Vehicle Inventory List

CITY OF LAS VEGAS INTER-OFFICE MEMORANDUM		DATE: October 8, 2015
TO: Land Development Services Department of Building & Safety		FROM: Albert Sung, P.E. Flood Control Project Engineer Department of Public Works
SUBJECT:	Drainage Study for: Vehicle Inventory Lot	COPIES TO: LanDesign Consultants
Cross Streets:	NWQ of Azure Drive & Tenaya Way	Centennial Azure LLC
File Number:	F:\Depot\DSMemos\DS4751A.doc	Bart Anderson, P.E., DevCo
Parcel Number:	125-27-101-035	CCPW?
Zoning Action:	SDR-60787	
FEMA Flood Zone	YES	NO X
Proposed Storm Drain	YES	NO X

TECHNICAL DRAINAGE STUDY

VEHICLE INVENTORY LOT

GRADING PLAN

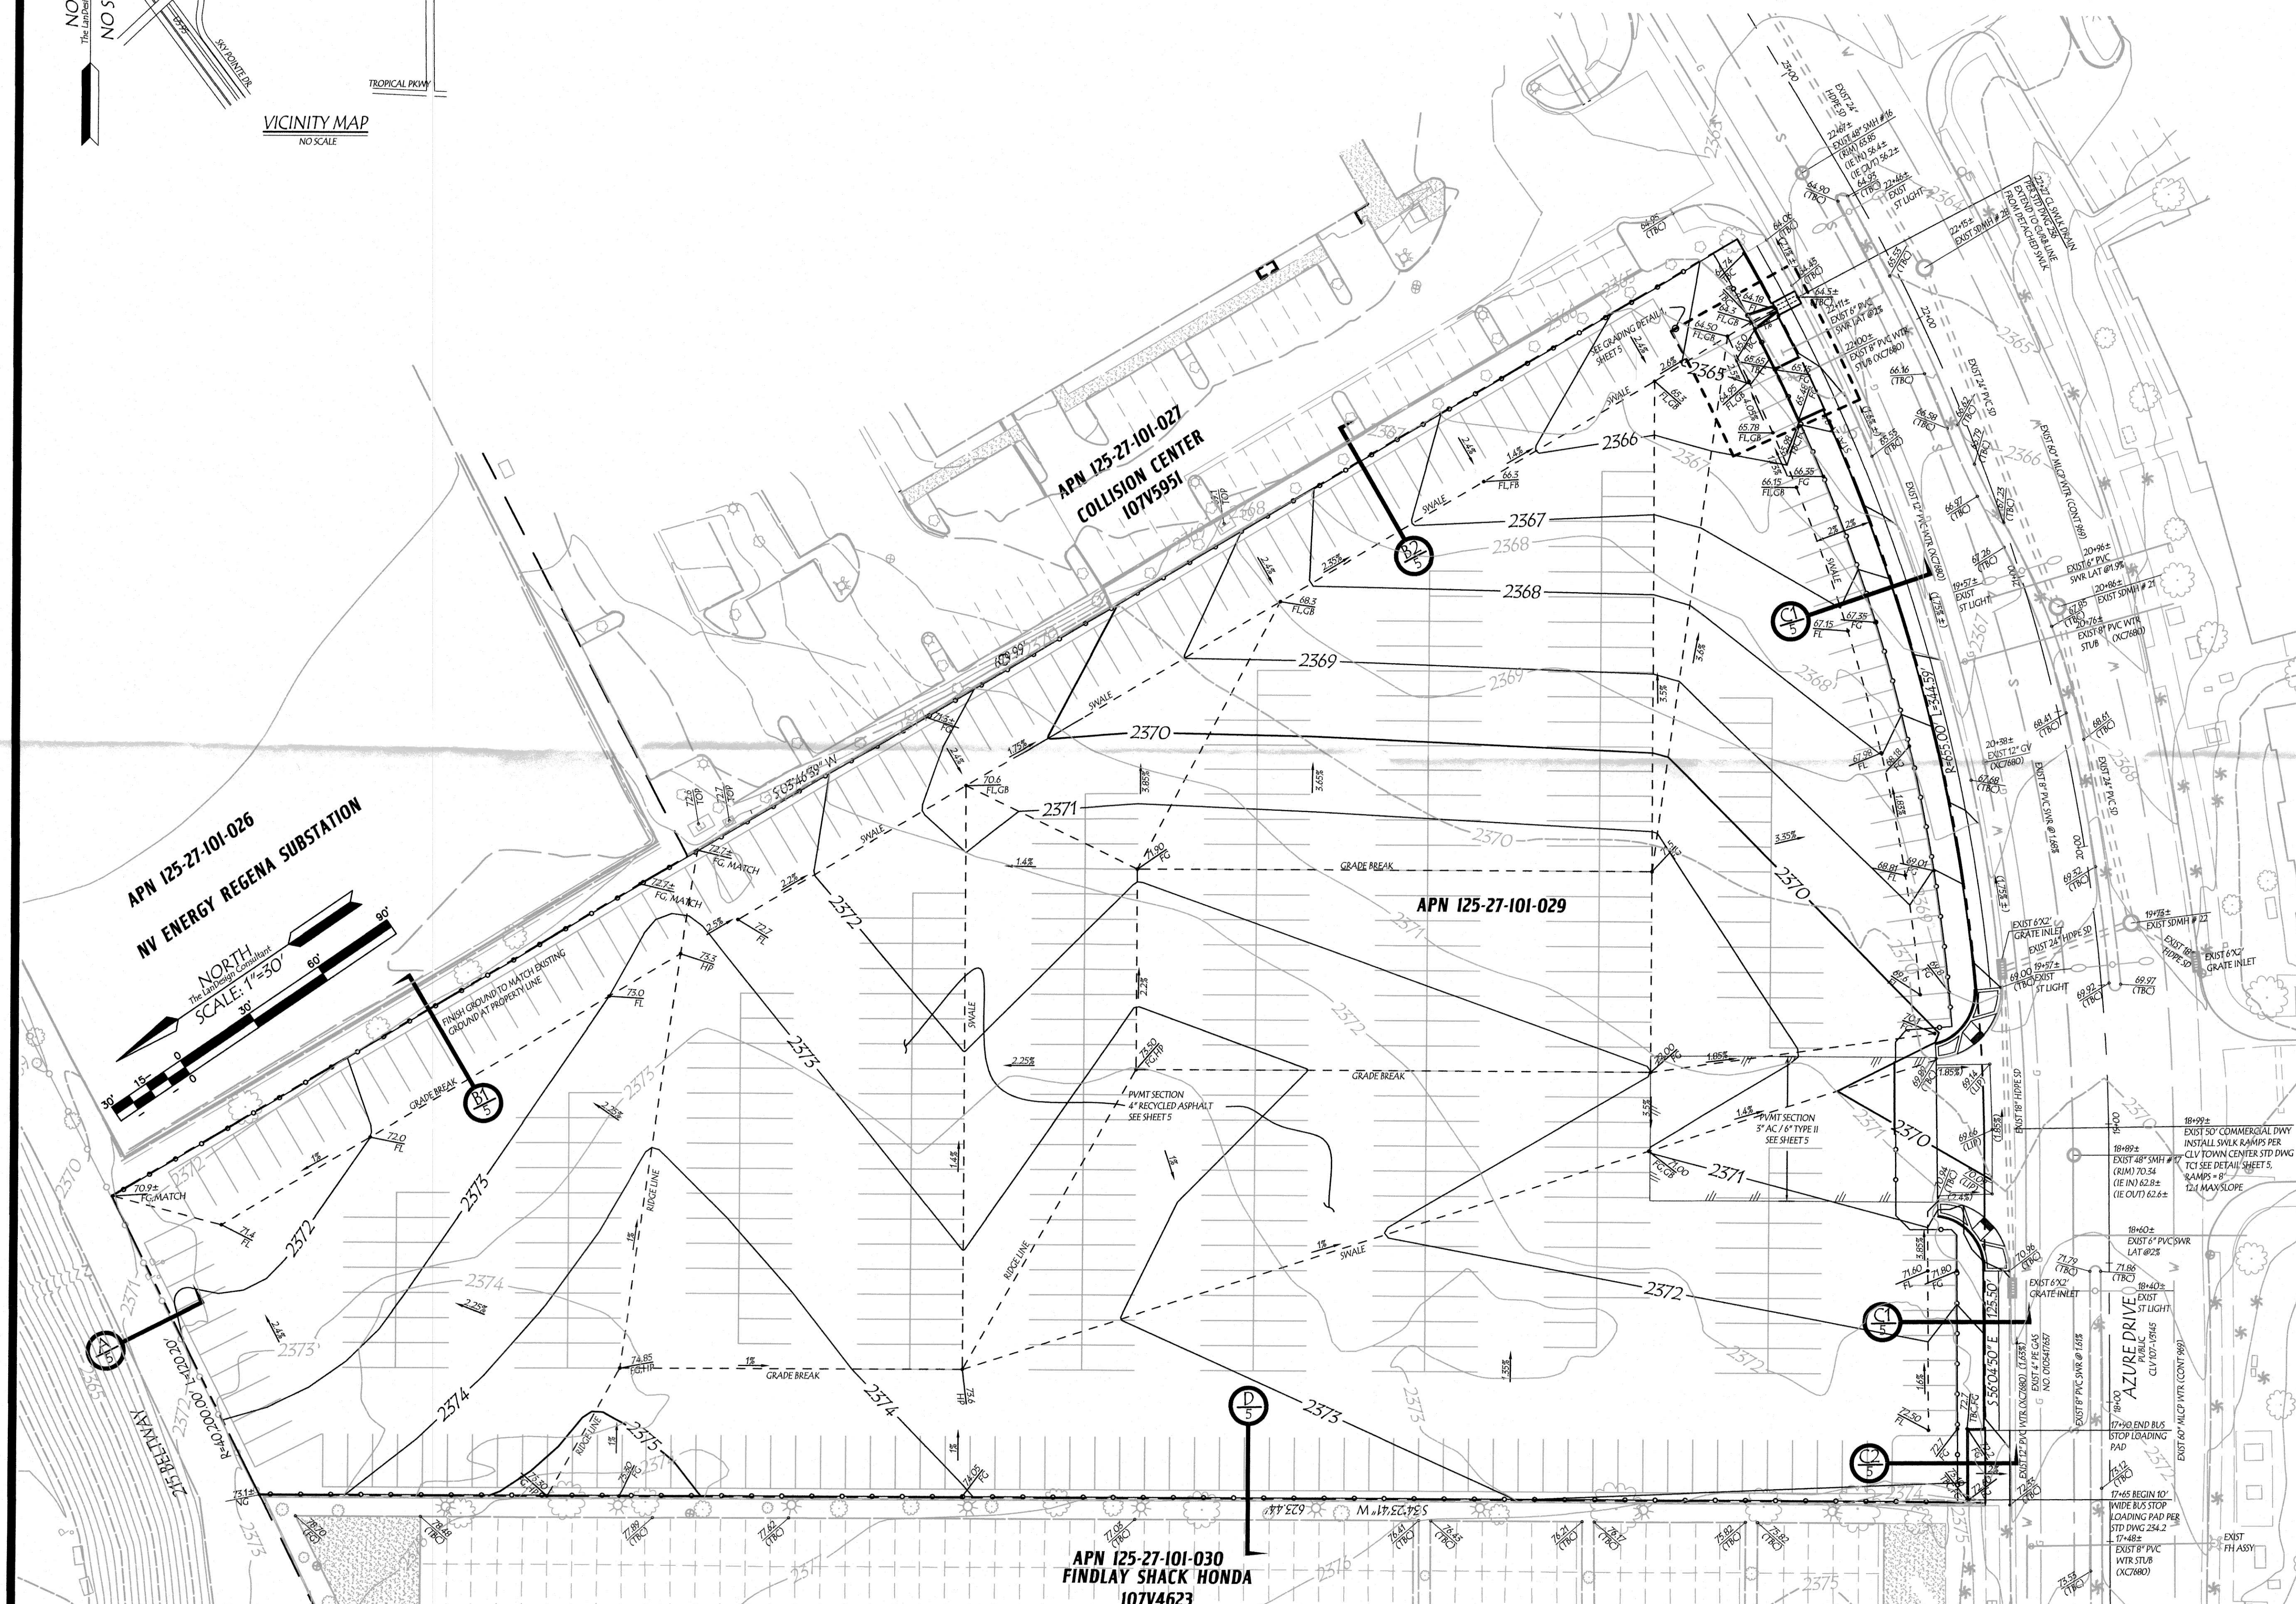
1. Label an existing storm drain system in *Azure Drive* with **City of Las Vegas** recorded drawing number on the grading plan.
2. Revise the assessor parcel number (APN) of the subject site to "APN: 125-27-101-035" on the grading plan.
